HISTORIC AND DESIGN REVIEW COMMISSION

HDRC CASE NO: 2020-575
ADDRESS: 732 N PINE ST
LEGAL DESCRIPTION: NCB 1659 BLK G LOT 1 AT 732 PINE N
ZONING: RM-6, H
CITY COUNCIL DIST.: 2
DISTRICT: Dignowity Hill Historic District
APPLICANT: John Perez/Castilla's Construction
OWNER: Adeel Riaz/MAJESTIC INVEST LLC
TYPE OF WORK: Demolition of accessory structure, rear porch enclosure
APPLICATION RECEIVED: December 18, 2020
60-DAY REVIEW: Not applicable due to City Council Emergency Orders
CASE MANAGER: Edward Hall
REQUEST:

**732 North Pine Street
San Antonio Texas 78202
Dignowity Hill Historical District**

**Mitigating Irreplaceable Loss by Reclaiming
from
Proposed Demolition of Detached Garage**

Exhibit B

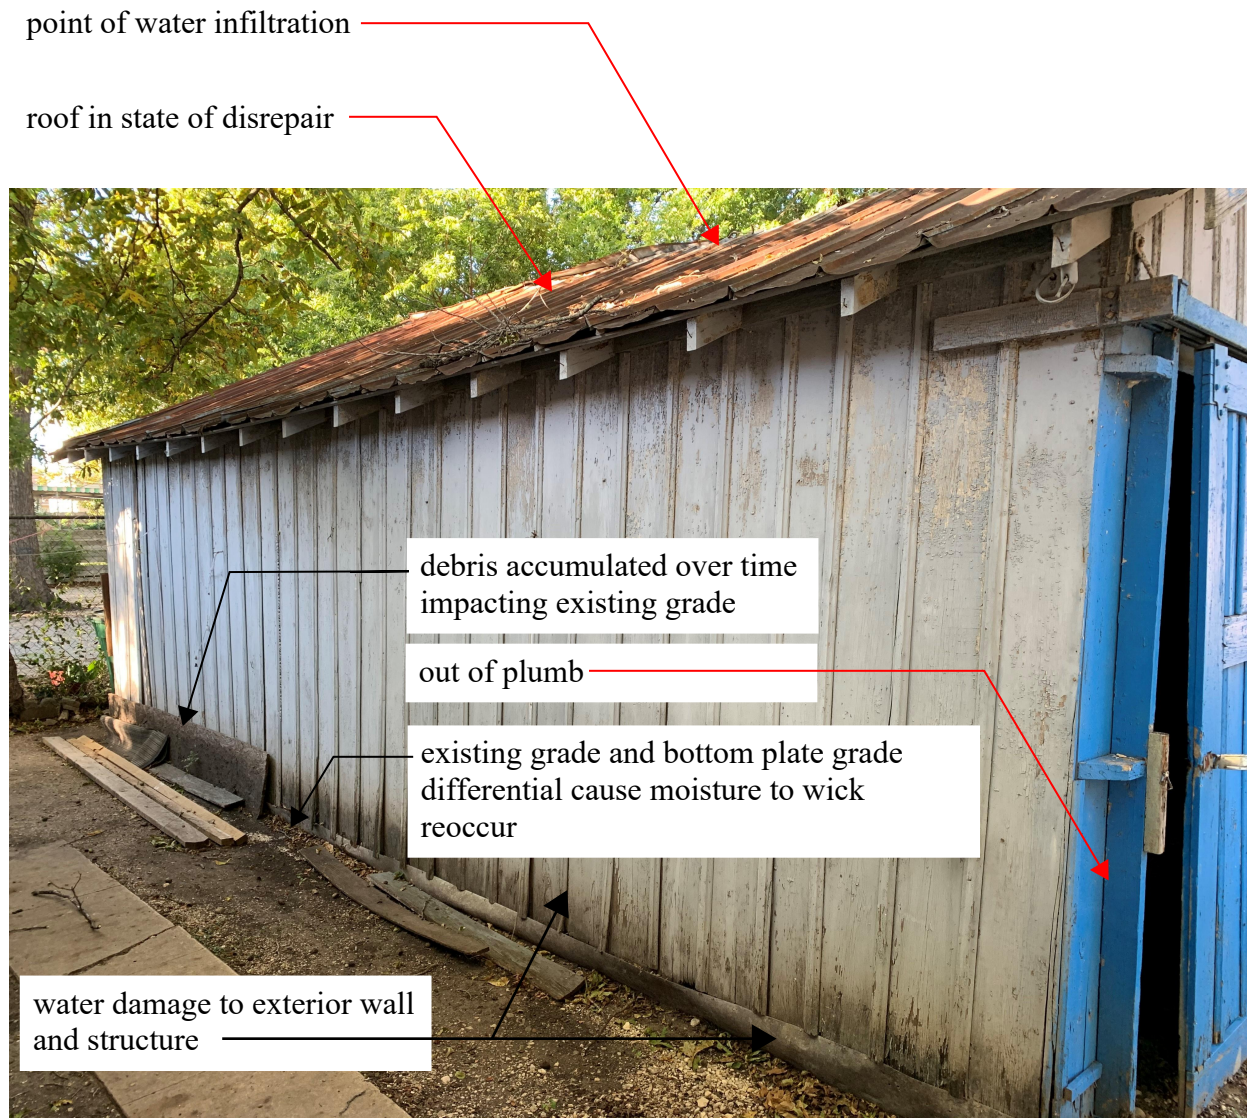
Water infiltration into the building. The water infiltration has weakened the existing roof framing structure and, in some areas, has attributed to structural failure of the roof framing causing a partial collapse.

Exhibit D

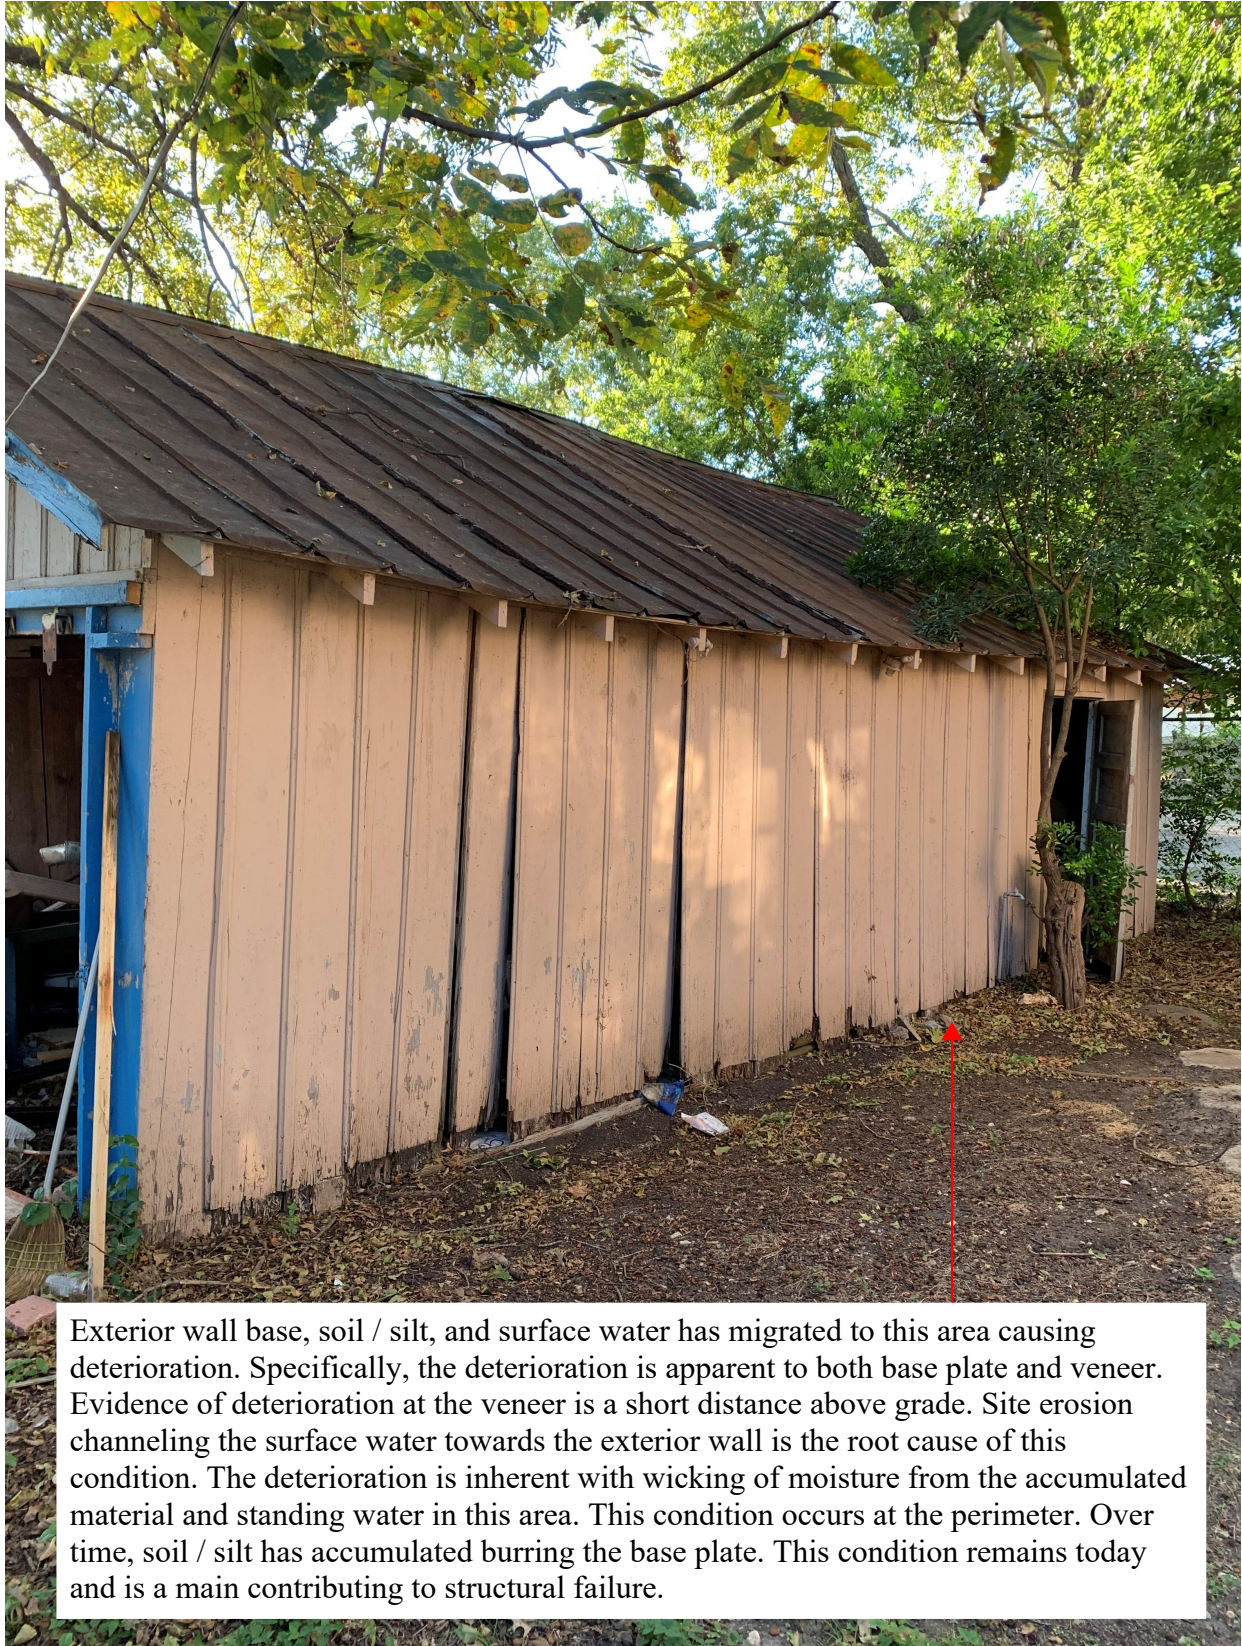
Exterior wall base, soil / silt, and surface water has migrated to this area causing deterioration. Specifically, the deterioration is apparent to both base plate and veneer. Evidence of deterioration at the veneer is a short distance above grade. Site erosion channeling the surface water towards the exterior wall is the root cause of this condition. The deterioration is inherent with wicking of moisture from the accumulated material and standing water in this area. This condition occurs at the perimeter. Over time, soil / silt has accumulated burring the base plate. This condition remains today and is a main contributing to structural failure.

Exterior wall base, soil / silt, and surface water has migrated to this area causing deterioration. Specifically, the deterioration is apparent to both base plate and veneer. Evidence of deterioration at the veneer is a short distance above grade. Site erosion channeling the surface water towards the exterior wall is the root cause of this condition. The deterioration is inherent with wicking of moisture from the accumulated material and standing water in this area. This condition occurs at the perimeter. Over time, soil / silt has accumulated burring the base plate. This condition remains today and is a main contributing to structural failure.

Water infiltration into the building. The water infiltration has weakened the existing roof framing structure and, in some areas, has attributed to structural failure of the roof framing causing a partial collapse

REAR PORCH - ORIGINAL CONDITION
732 N PINE ST

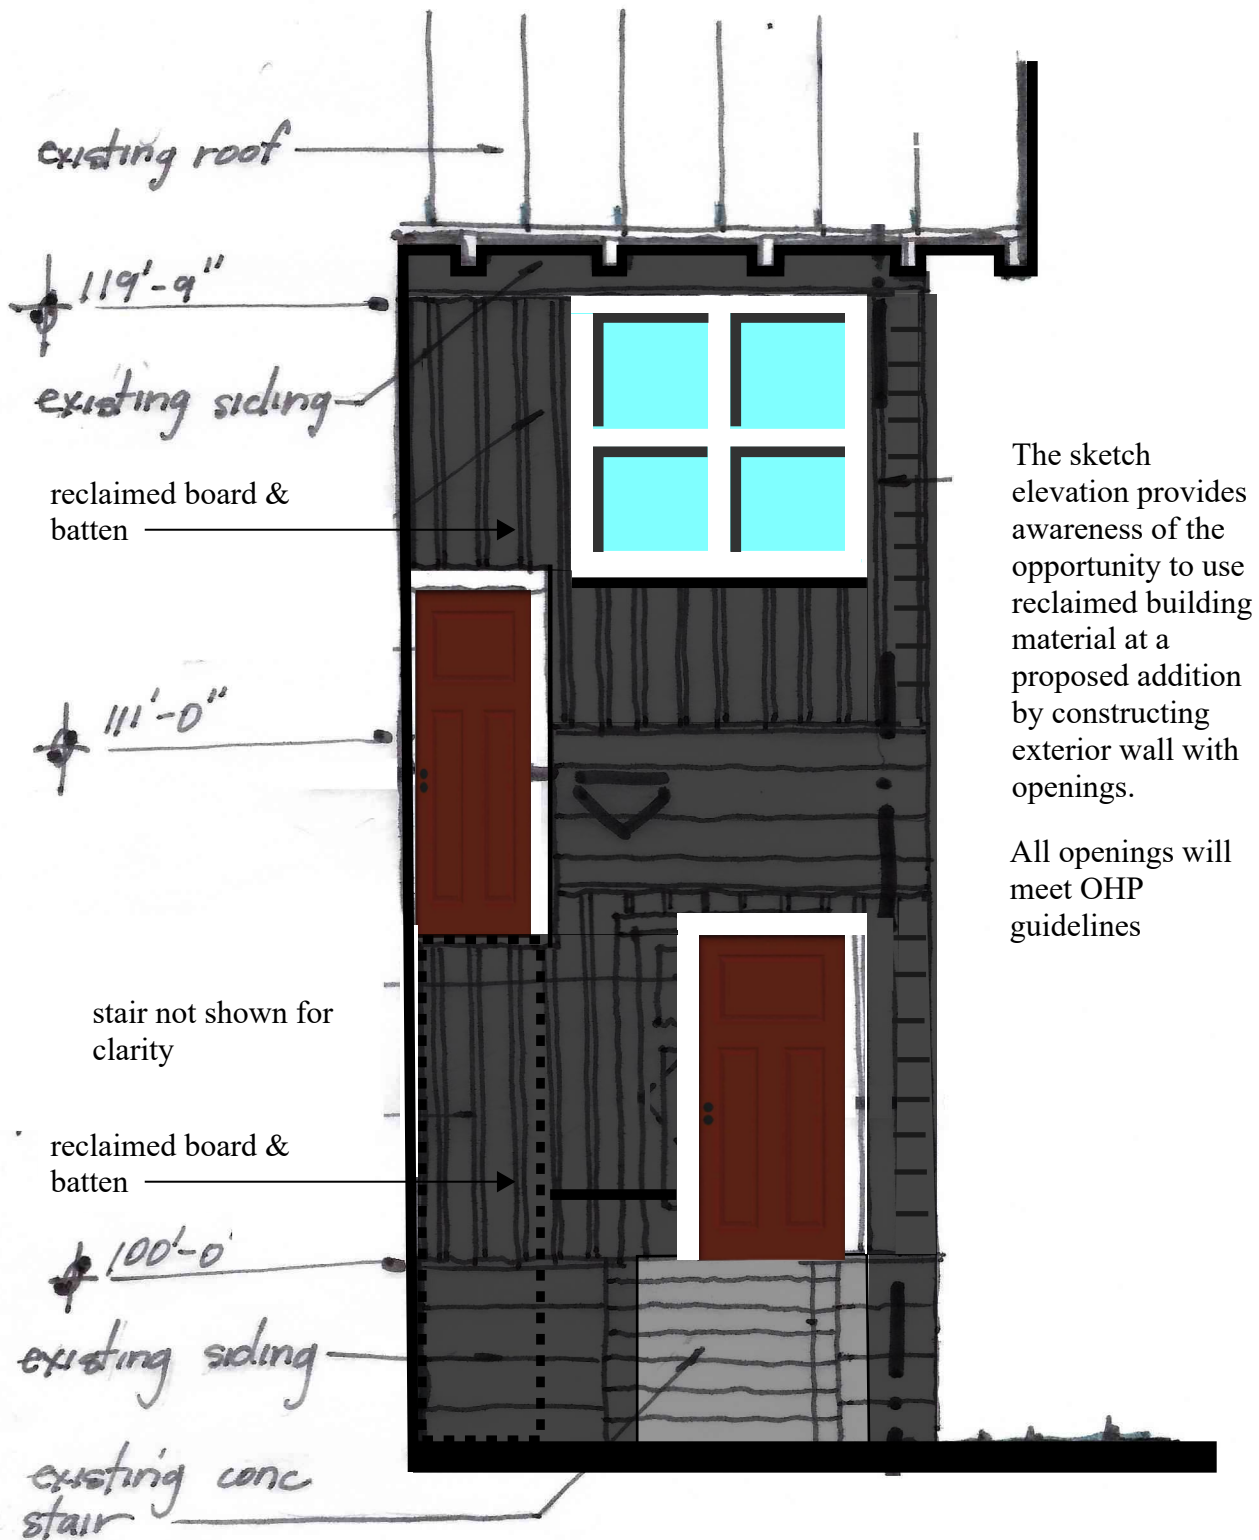
- g. REAR PORCH ENCLOSURE – The applicant has proposed to enclose an open air, rear porch at the rear (east facade) of the primary historic structure at 732 N Pine. The current porch has been informally enclosed with an open air lattice for an undetermined amount of time.

- h. REAR PORCH ENCLOSURE – Per the Guidelines for Exterior Maintenance and Alterations 7.B.ii., the enclosure of side and rear porches should be avoided, particularly when connected to the main porch or balcony. Original architectural details should not be obscured by any screening or enclosure materials. Additionally, the Guidelines note that alterations to side and rear porches should result in a space that functions, and is visually interpreted as, a porch. The applicant has proposed to enclose the rear porch, with a design resulting in a façade that features two doors and two windows. Staff finds that the proposed enclosure does not read as a porch, but rather reads as an addition. Staff finds that additional windows should be added to provide an open air appearance, resulting in an enclosure that reads as a porch.

The sketch elevation provides awareness of the opportunity to use reclaimed building material at a proposed addition by constructing exterior wall with openings.

All openings will meet OHP guidelines

- 1. Staff finds that the applicant has made a case for an unreasonable economic hardship, and recommends approval of the demolition of the rear accessory structure with the following stipulation:
 - i. That all existing siding is salvaged, regardless if it is used on site.
- 2. Staff does not recommend approval of item #2, the enclosure of the rear porch. Staff recommends the applicant amend the design to feature a rear porch enclosure that is consistent with the Guidelines, reading as a porch and featuring additional window openings on both the first and second level.
